# **As-built Baseline Monitoring Report**

**Cedar Branch Restoration Site  
Monitoring Year 00  
DMS Contract 6598  
DMS Project Number 97009**

## MEMORANDUM

Subject: Cedar Branch Stream Restoration Site  
MY-00 Monitoring Report Comments  
Yadkin River Basin CU 03040103  
Randolph County, North Carolina  
NCDMS Project # 97009  
Contract # 006598

Longitudinal Profile  
Cedar Branch- UTCC  
Monitoring Year 00, 2018

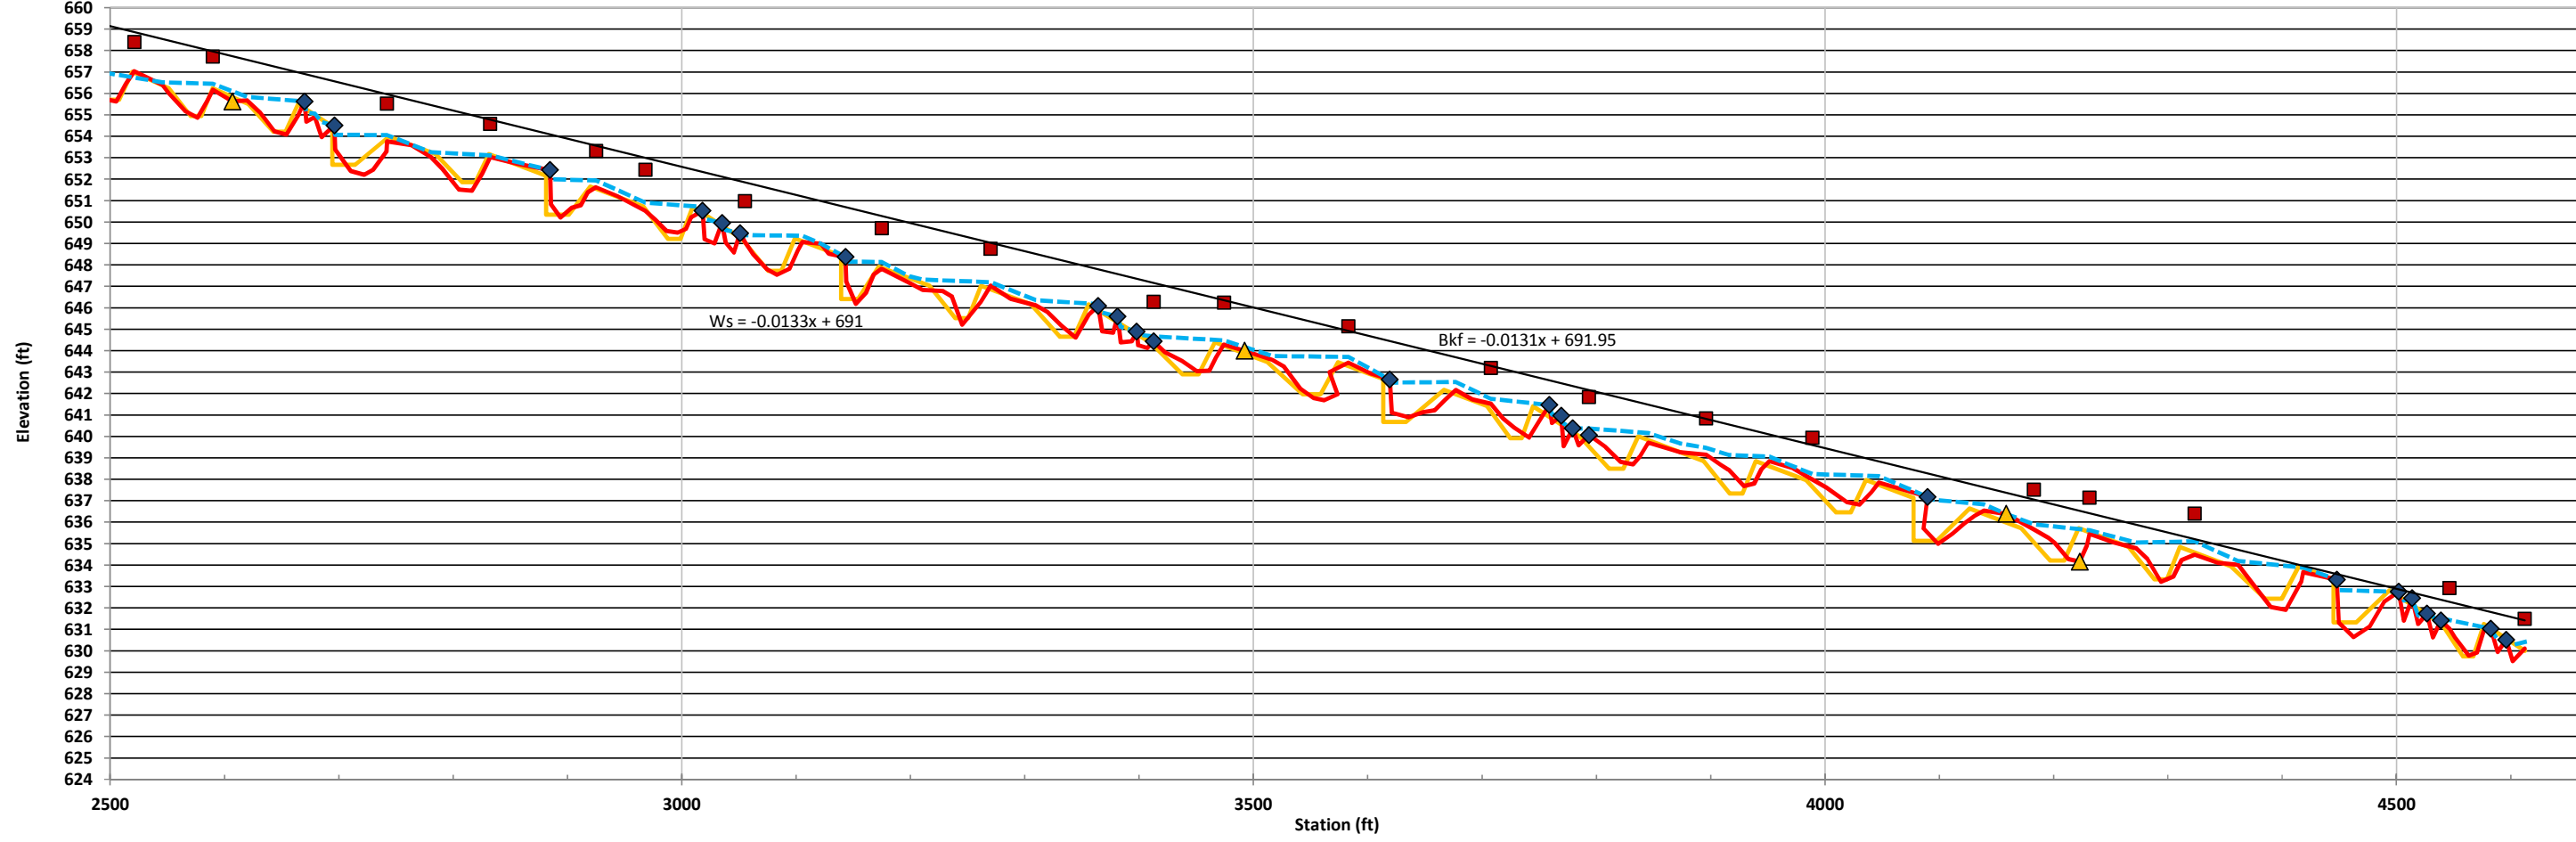
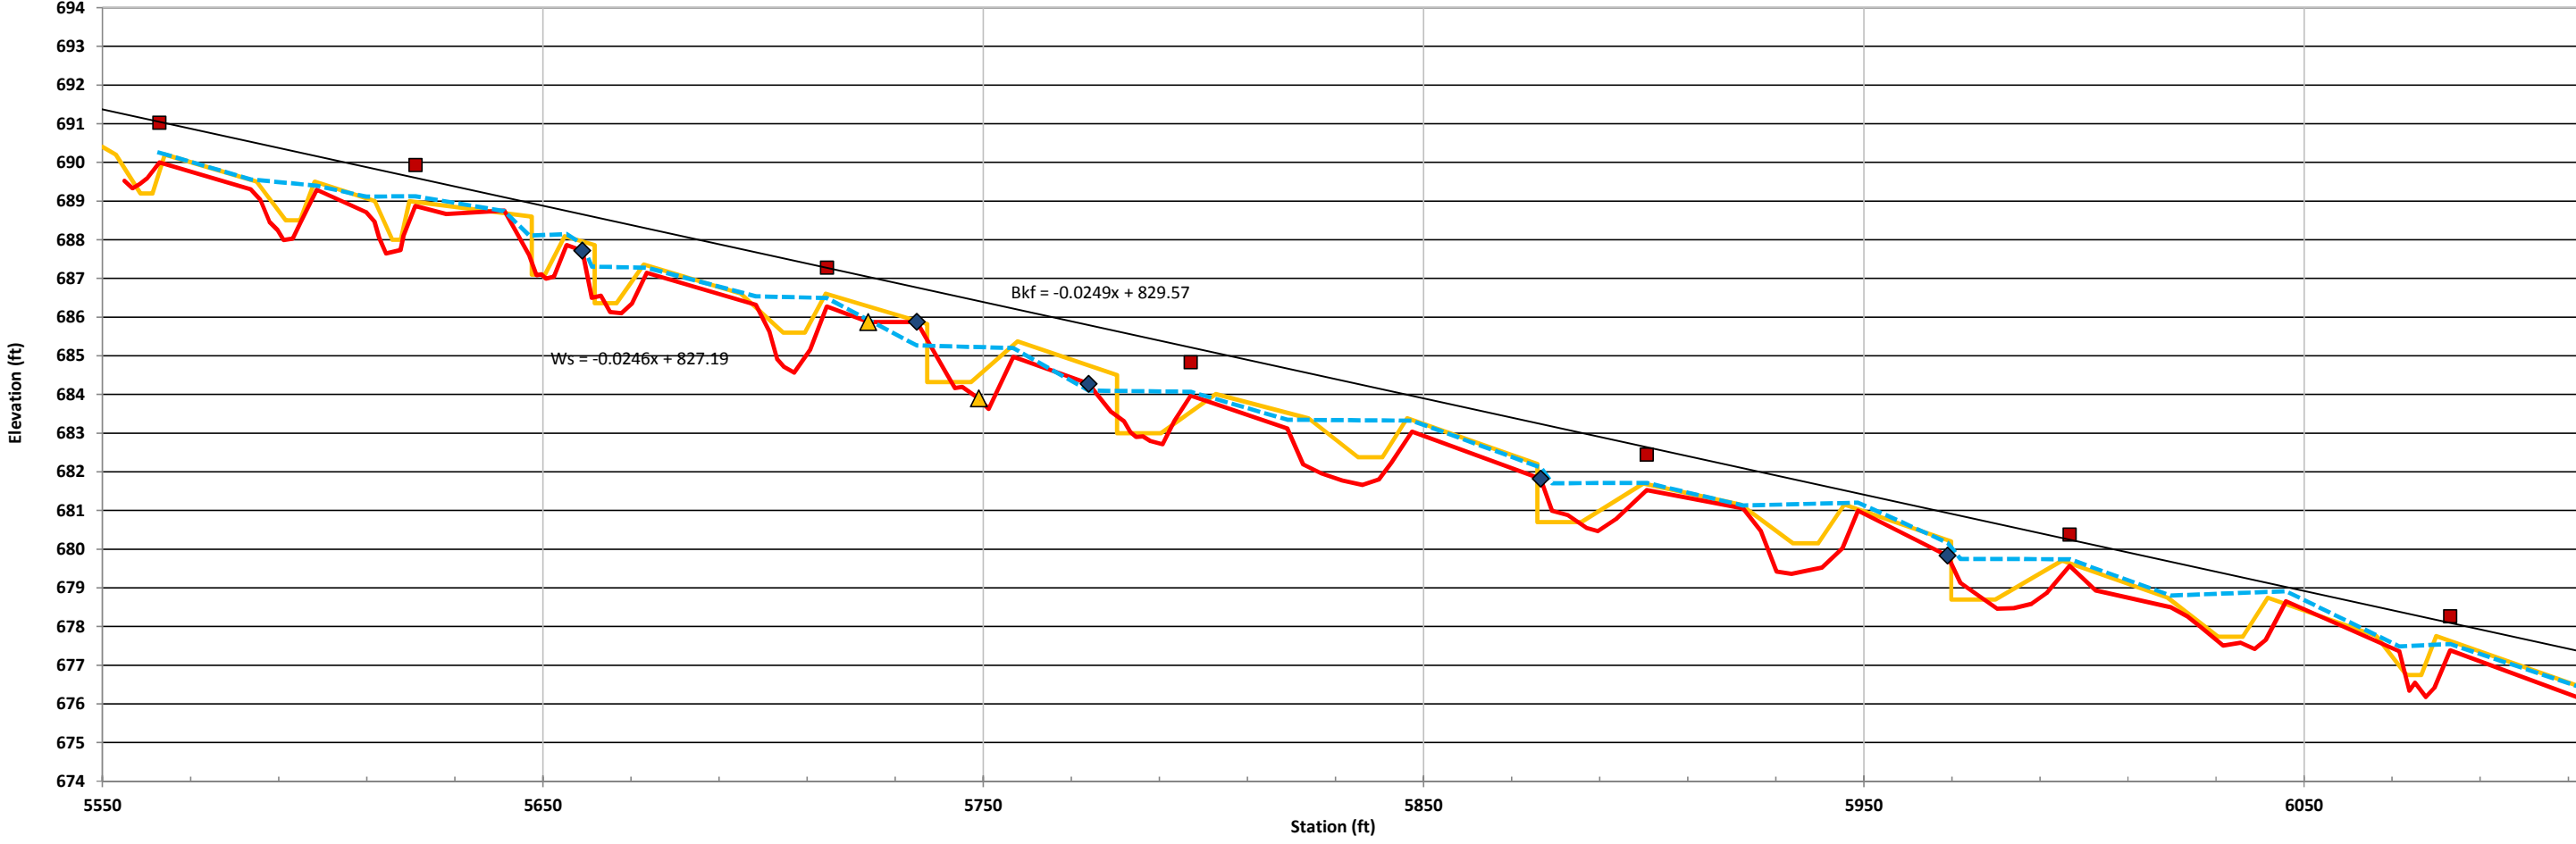
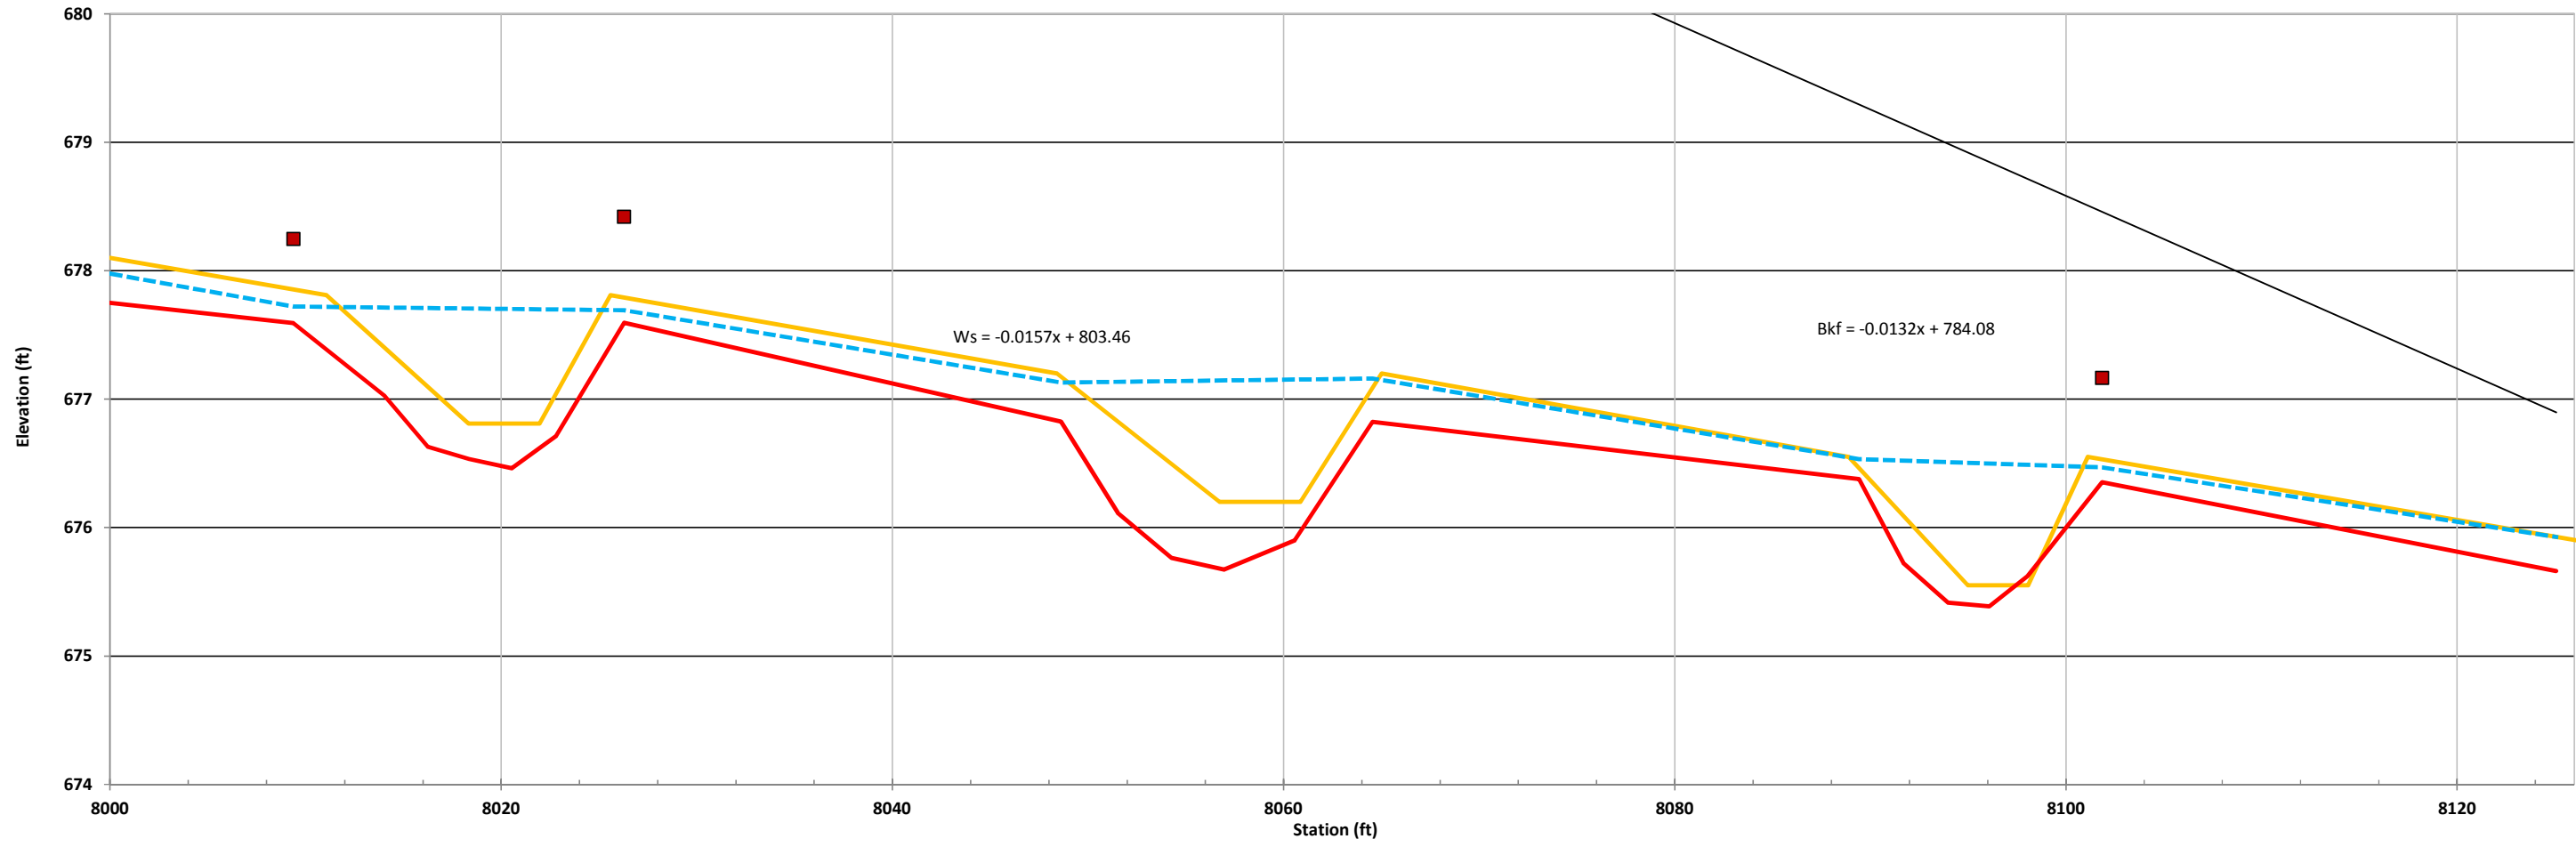
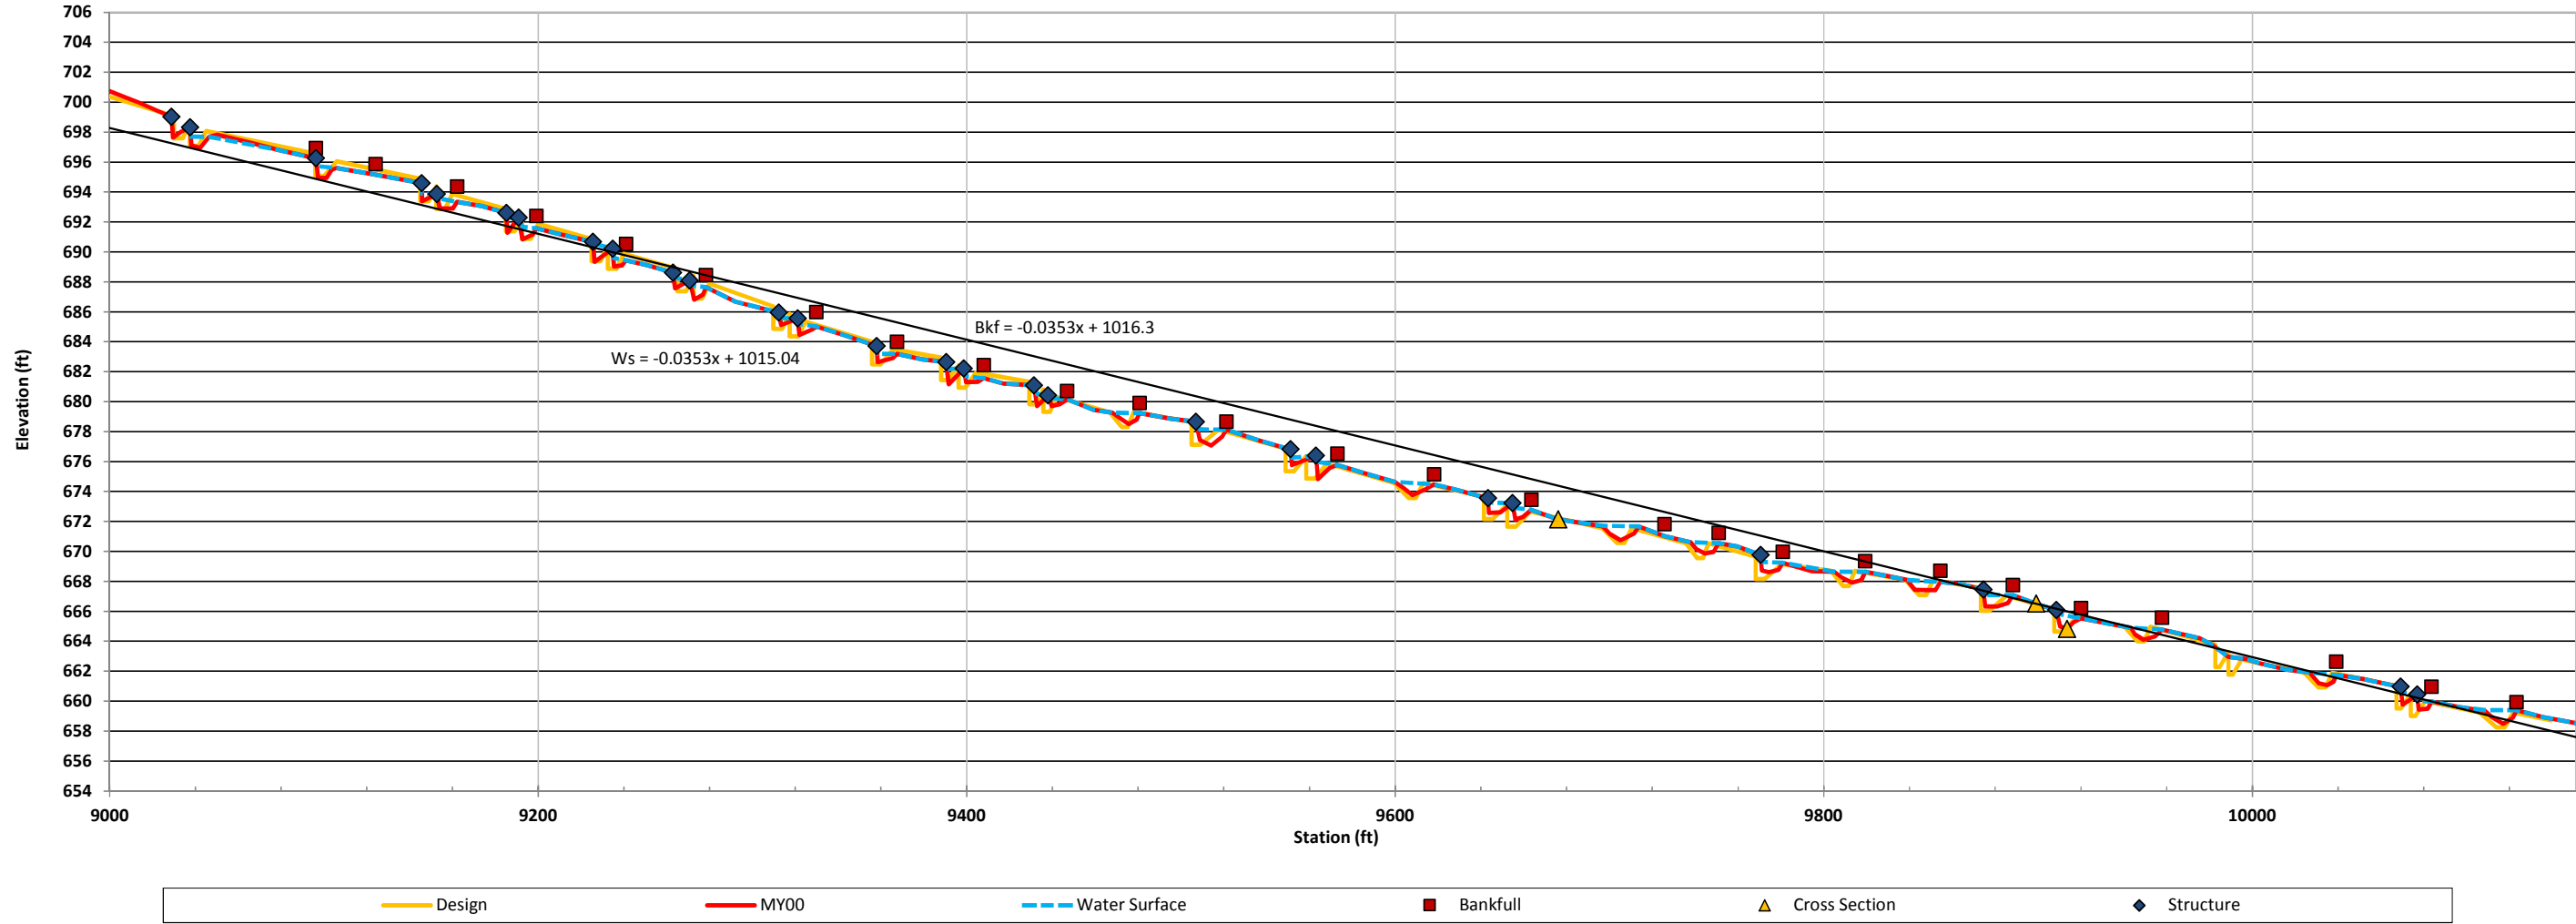
Please plot the design profile on the graph with the surveyed MY0 profile.

- *This has been added to the report.*
